Memorandum

Reference: Lunday Expert Evidence Peer Review Memo

From: Tim Church, Partner | Urban Designer, Boffa Miskell

Project No: BM191063G

Figure 1: Outcome of a sieve mapping approach identifying opportunities for urban expansion along Bannockburn Road.

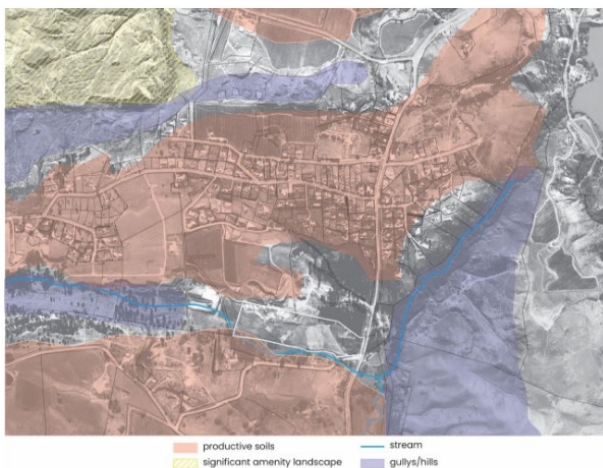
15. Mr Lunday has identified a 'Natural Town Growth Area' based on constraints mapping (Figure 1). Sieve mapping of various constraints layers is a well-recognised urban design method to identify potentially developable land. Although avoiding LUC 1 - 3 soils have been relied on as a valid constraint for development under National Planning Standard – Highly Productive Soils (NPS-HPS), it is noted that the Council's recently endorsed Vincent Spatial Plan also incorporated LUC 4 - 6 soils into its constraint mapping, which is understood to be suitable for irrigated viticulture and horticulture (e.g. stone fruit) production in Central Otago, and would need further consideration if this submission were to proceed.

16. Identifying readily developable land through constraints mapping is an acceptable starting point. Although, it needs to be complemented with further urban form analysis to understand the close relationship between land use densities and accessibility levels, as indicated by Mr Lunday (para 44). It is appropriate that Mr Lunday (para 46) and Ms White have both identified the southern corridor either side of Bannockburn Road for potential extension of the settlement. This would maintain a compact settlement along key movement routes that have the potential to support greater access choices, such as use of active travel modes (walking / cycling). Ms White describes this well below:

Figure 2: A contiguous extension of town is not apparent in the potential spatial pattern proposed by the submission.

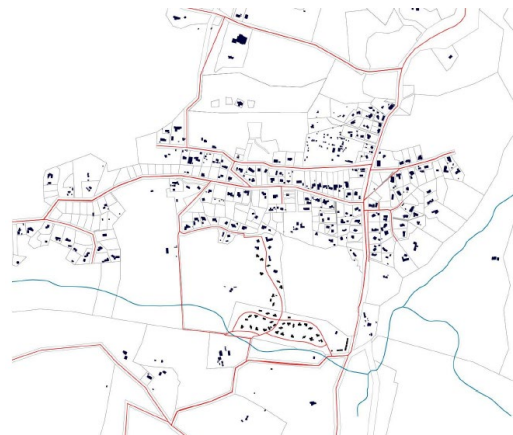
18. Thirdly, should the extent and definition of the ‘Natural Town Growth Area’ be accepted by the Hearings Panel from an urban form perspective, the next consideration is the effective integration of the Subject Site into its urban or rural context.
19. A structure plan has not been proposed for the urban extension of the Bannockburn settlement that from an urban design perspective would require holistic consideration of all other sites with the identified growth area (Figure 2). Only the Subject Site and adjacent Davies properties have been incorporated, as best illustrated in Mr Lunday’s concluding Nolly map.

20. Mr Lunday appears to support establishing a rural ‘Hamlet’ or cluster development concept that focuses on a smaller proportion of this available growth area, which is the focus of the Structure Plan provided in his evidence. However, it is noted on the Nolly map, included in Figure 17 of Mr Lunday’s evidence, that it might also anticipate utilising the Davies land as a future development corridor linking the proposed hamlet back into the settlement. The proposed land use zoning of this development has not been included in the proposed Structure Plan either. It also appears from this and the Indicative Masterplan that the proposed active travel route in this location would need to become a road alignment, if included.

21. From an urban design perspective, the proposed approach in the submission is likely to be both inconsistent with the clustering approach supported by Mr Lunday and less optimal than utilising a potential development corridor along Bannockburn Road. In either instance, Mr Lunday’s favouring of a cluster approach is likely to undermine the potential for other more contiguous development of this southern extension area in the future. It is generally more manageable to progressively stage urban growth into undeveloped land than infill existing development, particularly if recently developed. Otherwise, it typically results in more cellular and piecemeal growth patterns that are not optimal.

Figure 3: The Indicative Masterplan is unlikely to achieve a 'more sustainable' cluster model outcome compared to those identified as best practice by Mr Lunday.

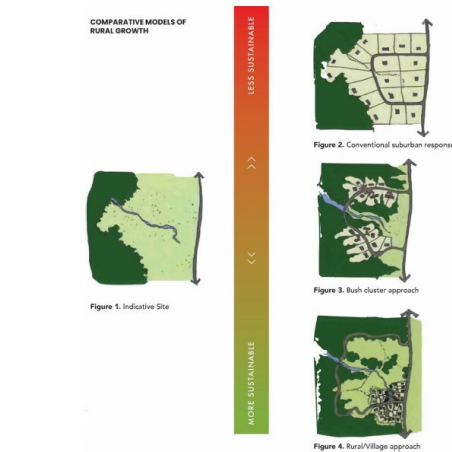
22. Mr Lunday outlines in his evidence the qualities of a best-practice hamlet developments (paras 50 - 54), including use of a case study with comparative modelling of rural growth with a presumably isolated, ‘Conventional Subdivision response’, which he regards as less sustainable, spanning through to a ‘Rural Village approach’ that is identified as more sustainable (Figure 3). While acceptable, the Indicative Masterplan based on the standalone, Subject Site does not appear to neatly fit with any of the

three models illustrated and is most likely to be a hybrid approach sitting between 'Conventional Subdivision' and 'Bush Cluster' approaches. Even if included within the broader, undeveloped Davies Site, this would unlikely fully achieve the 'Bush Cluster' approach, as discussed further in the next section below.

23. The proposed Draft Structure Plan and Indicative Masterplan, as currently presented in Mr Lunday's evidence, are not likely to achieve either a well-integrated part of the southern extension to the town or a more sustainable, self-contained hamlet. While both approaches may be able to be achieved through a Structure Plan for wider extension area and / or a Comprehensive Design for the Subject Site, respectively, the current proposal achieves neither satisfactorily and appears more of a 'halfway house' from an urban design perspective.

Figure 4: Morphology of Bannockburn maps illustrating that no clusters of development or accessways have previously been identified on the Subject Site

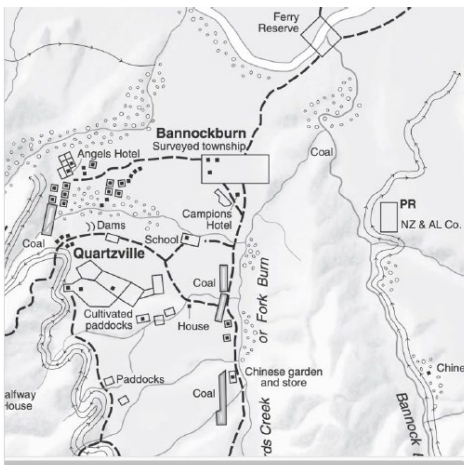
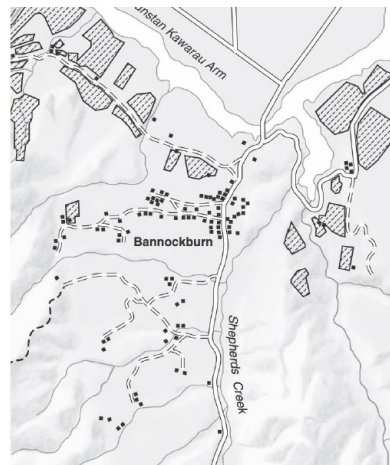
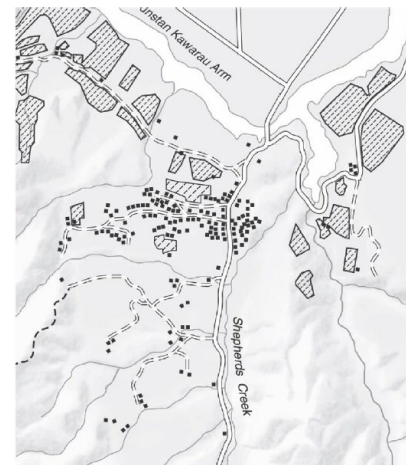
24. If a hamlet or cluster development approach was to be considered acceptable by the Hearings Panel, it is notable from the various historic maps referenced in Mr Lunday's evidence (Figure 4), that no other clusters of development or accessways have previously been recorded as existing on the Subject Site, other than a single dwelling. If a 'cluster' or 'hamlet' approach were to be established for a settlement, it would be a typical urban design approach to expand on existing clusters rather than establish a new one. A review of these historic maps and existing pattern of development, there appear to be other established clusters and / or access ways that there are likely to be more suitable candidates before consideration of the Subject Site is appropriate, such as the adjacent on southern side of Smiths Creek associated with the Old School.

Figure 5: Structure Plan does not clearly illustrate key elements of sustainable cluster development identified by Mr Lunday in the Indicative Masterplan, the likely distribution of private and common land or a logical / clearly defined defensible edge.

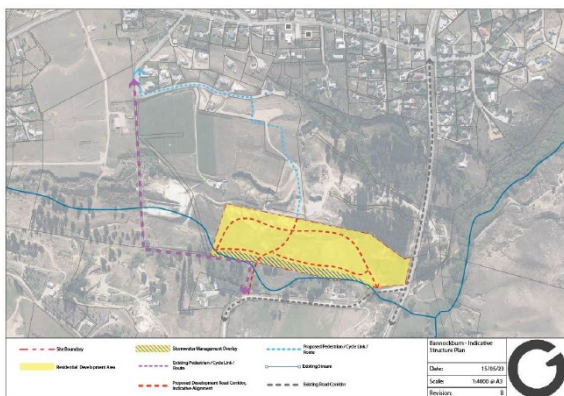
27. Notwithstanding its current isolation relative to the Bannockburn settlement, the draft structure plan provides three access points along its internal boundaries, which can appropriately future proof connectivity to adjacent sites should they be developed at later stages (Figure 5). The 'Community Hub' on Hall Road has been identified by Mr Lunday as a key destination (para 46). However, the existing and proposed pedestrian / cycle link / routes identified to the west and north provide indirect and lengthy access (c1300m), via Lyn Lane at the western end of the township, to this, despite it being in relative proximity directly to the north of the Subject Site (c200m). Given Mr Lunday's discussion on the integration merits of Bannockburn Road, referencing Hillier's Space Syntax theory, no provision has been made in the Draft Structure Plan for active travel routes along this road corridor that could more effectively access both community and commercial activities he has identified in the settlement.

28. The Draft Structure Plan illustrates a 'Residential Development Area' across the entire site with inclusion of a hatched 'Stormwater Management Overlay'. This does not clearly define the key elements of sustainable cluster development, likely distribution of private and common land or a logical / clearly defined defensible edge discussed by Mr Lunday in his evidence (paras 69, 73 and 76).

29. Typical clustering approaches tend to be more tightly packed with internal public frontages to a common access way and private backs broadly radiating out, offering opportunities for social interaction and shared infrastructure internally with a sense of openness and landscape continuity externally. This can be an appropriate approach to comprehensively designed larger, isolated sites. However, the Indicative Masterplan appears to have a relatively even distribution of houses spread across the rectangular Subject Site with internal boundary setbacks not noticeably wider than separation between houses internally. As such, it is hard to identify how the proposed cluster approach discussed in Mr Lunday's evidence (paras 50 - 54) can be genuinely achieved without reducing yield or relying on the adjacent sites either remaining undeveloped or at least underdeveloped. Should this same pattern of development continue across adjacent sites, then it would be less of a cluster pattern and more consistent with other LLRZ outcomes, albeit boundary treatments would be less defined and slightly denser. As such, it is difficult to peer review the likely outcomes of the proposed rule amendments (i.e. minimum site area per residential unit is 400m² while maintaining an average across the precinct of 1,000m²) without these parameters illustrated.

30. Furthermore, the Indicative Masterplan identifies cottages along Bannockburn Road that appear to be more compact built forms than anticipated in the LLRZ or reflected elsewhere in the township and Mr Lunday notes that these could be adapted to commercial use in the future (para 69). These could be appropriate if the proposed 'Hamlet' approach was to be applied, but are neither appropriately zoned nor well-integrated with the other parts of the Subject Site.
